Authors Response (AR) to RC #1

This paper presents a novel algorithm for deriving below-ground urban stormwater networks using graph theory concepts. The paper is well written, well-articulated, and presents application to both urban hydrologic modeling and broad Earth system modeling. Although the manuscript is heavy on the method description, the applicability of the algorithm is clearly illustrated with 4 case studies. I think some shifting of paragraphs are needed to make the paper flow better. I also have some minor comments for the authors to consider.

Figure R2. Our adapted version of Figure 1

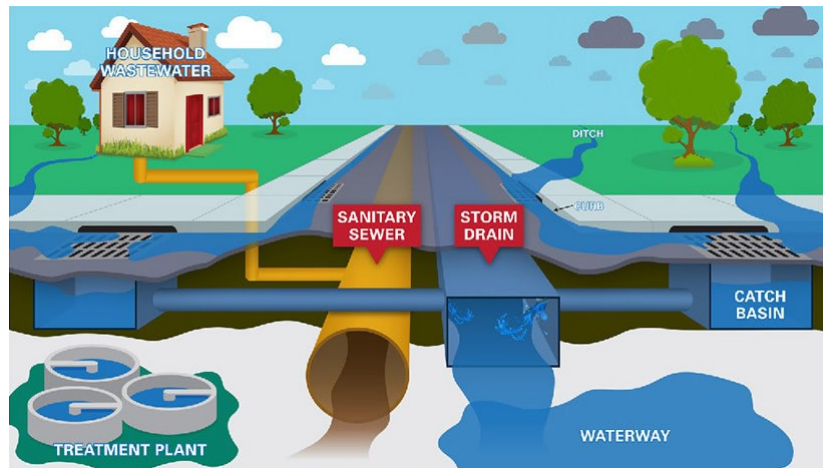
11. *Is Figure 1 an original creation or is it obtained from other sources? Please ensure that IP is not infringed.*

AR: This figure is adapted from Town of Gilbert, AZ (2022) but with substantial modifications. Below please see the comparison between the original version and our version.
